Access Compliance Report

Public Rights-of-Way

Intersection ID: 10011741	Main Street: N_SHARON_AMITY_RD	Cross Street: N/A	Location: NE
ADA ID: 6E51B5216B12	Ramp Type: PerpDiag	Initial Pass/Fail: Fail	Overall Compliance: No
Severity Score: 22.5			
Codes/Mitigation Info/Possible Solution		Field Measurements/Component Compliance

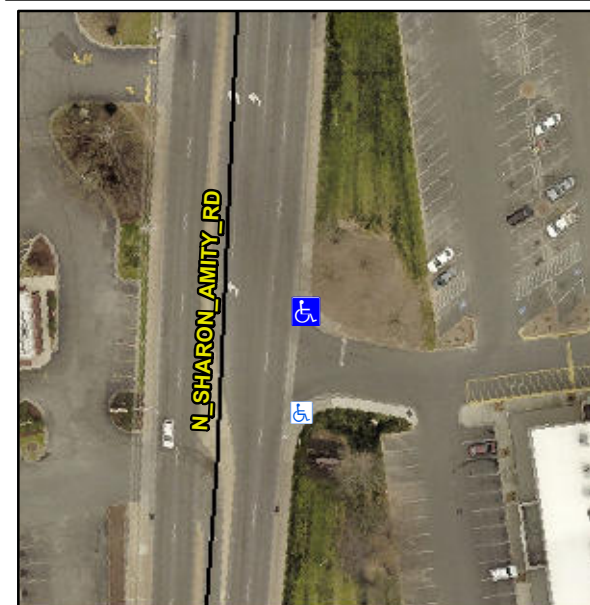
Not Found, R304.5.1, R304.2.2, R304.5.3

Compliance	Description	Data	Compliance	Description	Data
N/A	Ramp Length (in)	60.0	No	Ramp Slope (%)	9.6
No	Ramp Width (in)	36.0	No	Ramp XSlope (%)	4.0
N/A	Flare Type LT	N/A	N/A	Flare Type RT	N/A
N/A	Flare Slope LT (%)	N/A	N/A	Flare Slope RT (%)	N/A
N/A	Flare Traversable LT?	N/A	N/A	Flare Traversable RT?	N/A
N/A	Landing Length (in)	N/A	N/A	DWS Provided?	N/A
N/A	Landing Width (in)	N/A	N/A	DWS Contrast?	N/A
N/A	Landing Slope (%)	N/A	N/A	DWS Length (in)	N/A
N/A	Landing X Slope (%)	N/A	N/A	DWS Full Width?	N/A
N/A	Landing Curb? (Y/N)	N/A	N/A	DWS Offset (in)	N/A
N/A	Shared Landing?	N/A			
N/A	Gutter Ponding?	N/A	N/A	Gutter Slope (%)	N/A
N/A	Gutter Lip Ht (in)	N/A	N/A	Gutter X Slope (%)	N/A
N/A	Painted X Walk1?	No	N/A	Painted X Walk2?	No
	X Walk 1 Direction	To W		X Walk 2 Direction	To S
N/A	X Walk 1 Width (in)	N/A	N/A	X Walk 2 Width (in)	N/A
	X Walk 1 Slope (%)	1.9		X Walk 2 Slope (%)	1.3
	X Walk 1 X Slope (%)	0.5		X Walk 2 X Slope (%)	4.4

Remove & Replace Curb Ramp With Two New Directional Ramps or Equivalent.
